Review of (revised version of)
Improved representation of the contemporary Greenland ice sheet firn layer by IMAU-FDM v1.2G by Brils et al.

Reviewer: C. Max Stevens

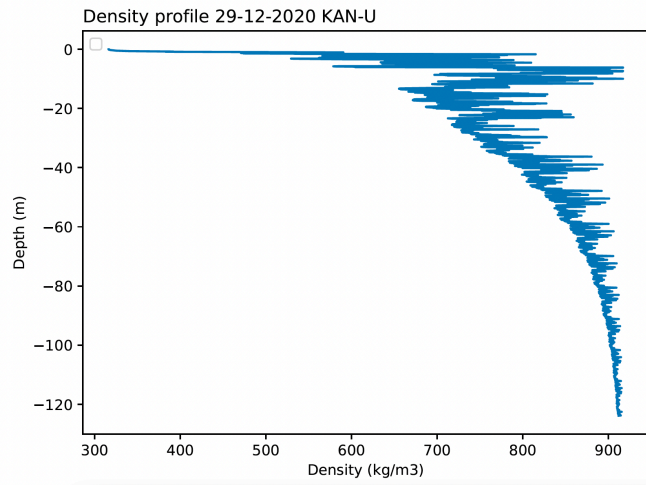
239: I agree with you that this is probably a fine assumption to make on the spatial scales you are looking at – but I would appreciate a bit of discussion on the implications of that vis-à-vis the discussion of ice lens formation in your introduction: can thick ice lenses/slabs form while using this assumption, or is it necessary to be able to include ponded water?

While it is true that our model does not simulate melting water, it does not prevent the formation of ice lenses in Southwest Greenland. This can, for example be seen in this profile from KAN-U in 2020:

It must be noted, however, that the modelled ice slabs consist of multiple thin layers of high density ice, often interlaid with a thin layers with slightly lower density. In reality, a thick ice slab was formed at KAN-U in 2012 (see for example Rennermalm et al. (2021)). The absence of ponding may be what is causing this behaviour. We have added this discussion to the manuscript, and the firm density profile has been added to the supplementary material.
